CERTIFICATE OF APPROPRIATENESS

Property: 1409 Ashland Street, Lot 16, Tract 17A, Block 151, Houston Heights Subdivision. The property includes a historic 1,114 square foot, one-story wood frame single-family residence and a detached secondary structure situated on a 6,600 square foot (50' x 132') interior lot.

Proposal: Alteration – Resubmittal

EAST ELEVATION – FRONT FACING ASHLAND STREET

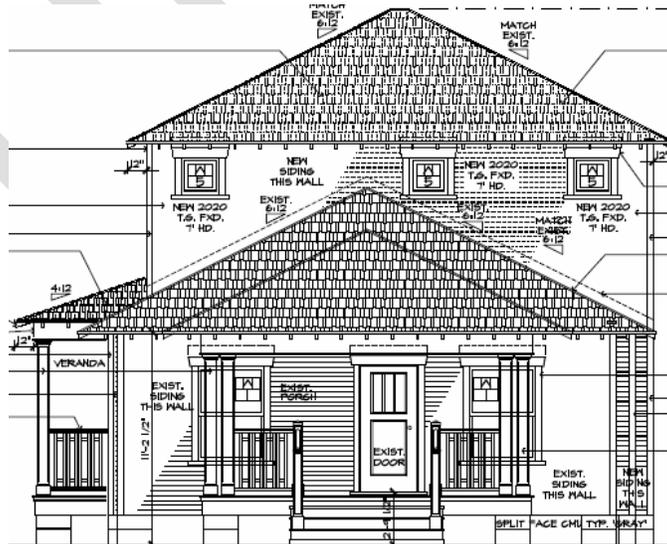
Front Elevation: The residence features two windows and a front door to be retained. Existing non-original porch (East) floor, stairs and railings will be removed and replaced. Existing non-original square columns will be removed and replaced with two pairs of 8" square fiberglass columns. The addition will feature three windows on the second floor and will extend 1'-11" from the existing north wall on both floors. The second floor will be inset 1' from the south wall on the second floor. A direct vent wood-sided chimney will extend 6" out to the south from the south wall. See elevation drawings for details.

NORTH SIDE ELEVATION

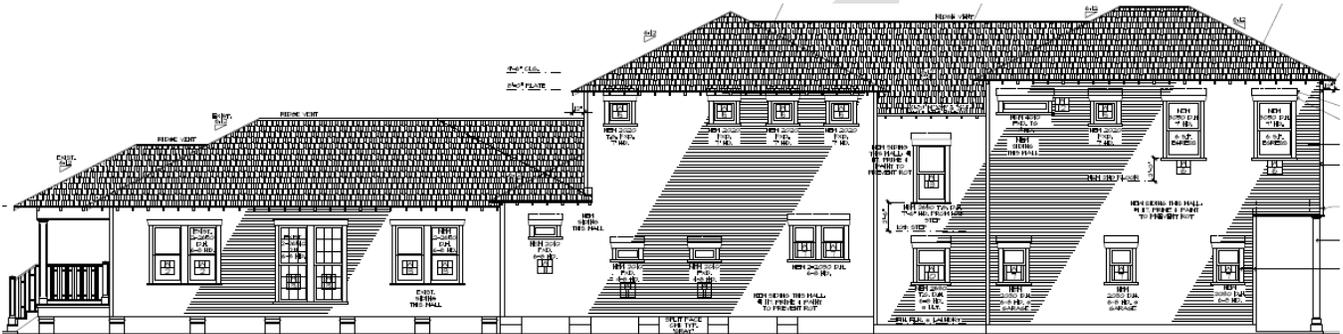
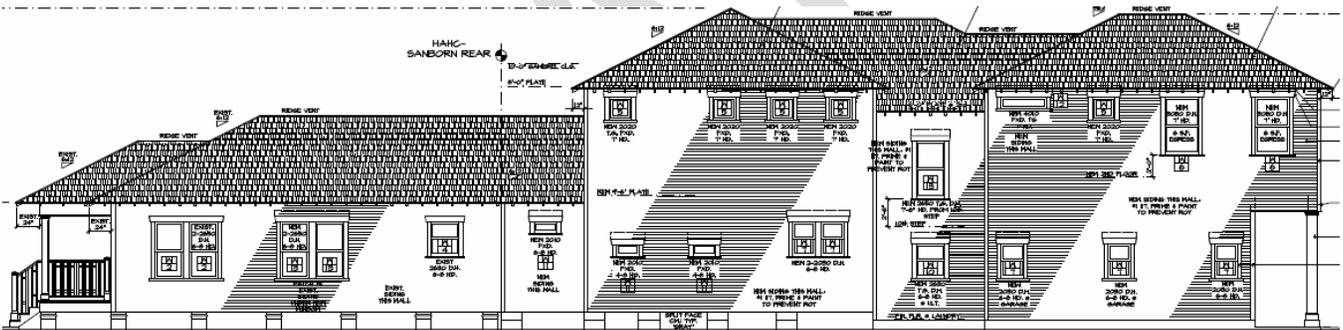
Side Elevation: The residence features a pair of wood windows to be retained, a pair of aluminum windows to be removed and replaced with wood windows and a single wood window to be retained. An existing rear shed addition will be removed and the addition will begin at the original rear wall and feature nine windows on the first floor and nine windows on the second floor. See elevation drawings for details. (North)

- The addition will be 2,513 square feet
- The addition's rear eave height will decrease to 21'-2"
- The addition will extend 1' wider and maintain the existing roof line on the north side
- The addition will inset 1'-6" on the south side
- All existing original wood windows and siding will be retained

SOUTH SIDE ELEVATION

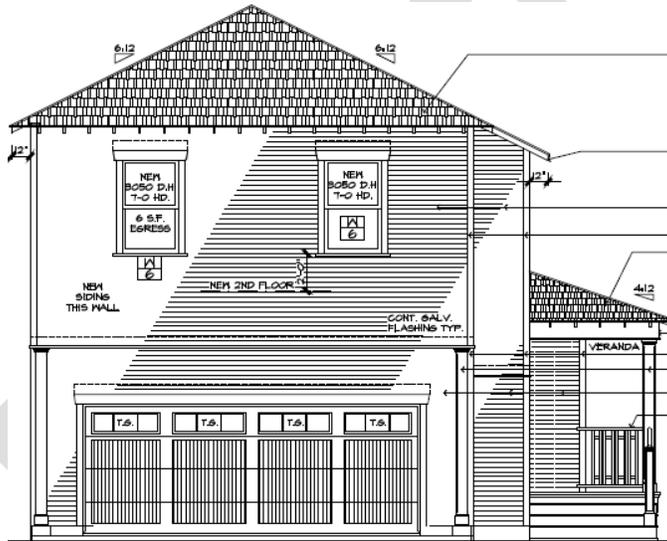
Side Elevation: The residence features, from east to west, a pair of wood windows to be retained, an aluminum window to be removed and replaced with a wood window, a pair of wood windows to be retained and a pair of wood windows on an existing addition to be removed. The addition will retain a portion of the existing addition's wall and start 7'-10" behind the original rear wall, inset 1' for 3'-4" before popping back put 2'-6" to a 7'-4" wide direct vent chimney on the first floor. The addition will then extend back 23'-10", step back and extend a final 29'-1" including a 5'-9" portico covered by conditioned space on the second floor. The second floor will feature seven windows. The first floor will feature two windows and a door at the rear garage portion. A side porch (South)

measuring 21'-9" wide by 6'-10" deep will begin after the direct vent chimney. The wall behind it will feature two pairs of doors and a window. See elevation drawings for details.
